# Access Compliance Report

## Public Rights-of-Way

### (Curb Ramps)

Intersection ID: 28129	Main Street: OLIVIA_LN	Cross Street: ORCHID_PL	Location: NW
ADA ID: 59F6FDC6F582	Ramp Type: BlendTrans2	Initial Pass/Fail: Fail	Overall Compliance: No
Severity Score: 35			
Codes/Mitigation Info/Possible Solution		Field Measurements/Component Compliance

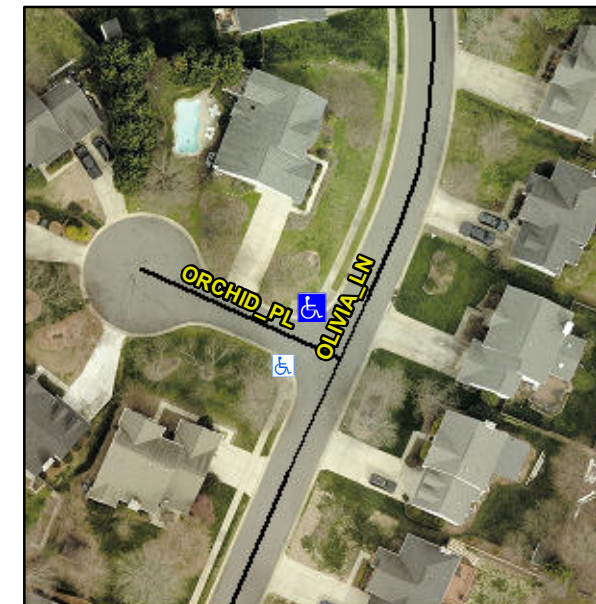
**Not Found, R304.5.1**

Compliance	Description	Data	Compliance	Description	Data
N/A	Ramp Length (in)	94.5	Yes	BlendTrans Slope (%)	4.8
No	Ramp Width (in)	25.0	Yes	BlendTrans XSlope (%)	0.0
N/A	Flare Type LT	N/A	N/A	Flare Type RT	N/A
N/A	Flare Slope LT (%)	N/A	N/A	Flare Slope RT (%)	N/A
N/A	Flare Traversable LT?	N/A	N/A	Flare Traversable RT?	N/A
N/A	Landing Length (in)	N/A	N/A	DWS Provided?	N/A
N/A	Landing Width (in)	N/A	N/A	DWS Contrast?	N/A
N/A	Landing Slope (%)	N/A	N/A	DWS Length (in)	N/A
N/A	Landing X Slope (%)	N/A	N/A	DWS Full Width?	N/A
N/A	Landing Curb? (Y/N)	N/A	N/A	DWS Offset (in)	N/A
N/A	Shared Landing?	N/A			
N/A	Gutter Ponding?	N/A	N/A	Gutter Slope (%)	N/A
N/A	Gutter Lip Ht (in)	N/A	N/A	Gutter X Slope (%)	N/A
N/A	Painted X Walk1?	No	N/A	Painted X Walk2?	No
	X Walk 1 Direction	To SW		X Walk 2 Direction	To SE
	X Walk 1 Width (in)	N/A		X Walk 2 Width (in)	N/A
	X Walk 1 Slope (%)	0.9		X Walk 2 Slope (%)	3.0
	X Walk 1 X Slope (%)	3.3		X Walk 2 X Slope (%)	0.0

N/A	Ramp inside XWalk1?	N/A	N/A	Ramp inside XWalk2?	N/A
	Road Slope (%)	2.1		Clear Space?	N/A
	Road X Slope (%)	4.8	N/A	Clear Space to XWalk (in)	N/A
N/A	Any Obstructions?	N/A	N/A	Storm Grate/Utility Hazard?	N/A
	Obstruction Type			Storm Grate/Utility Type	
		N/A			N/A
			Yes	Surface Condition? (G/P)	Good
			No	Curb Slope (%)	8.2

**Remove & Replace Curb Ramp With Two New Directional Ramps or Equivalent.**
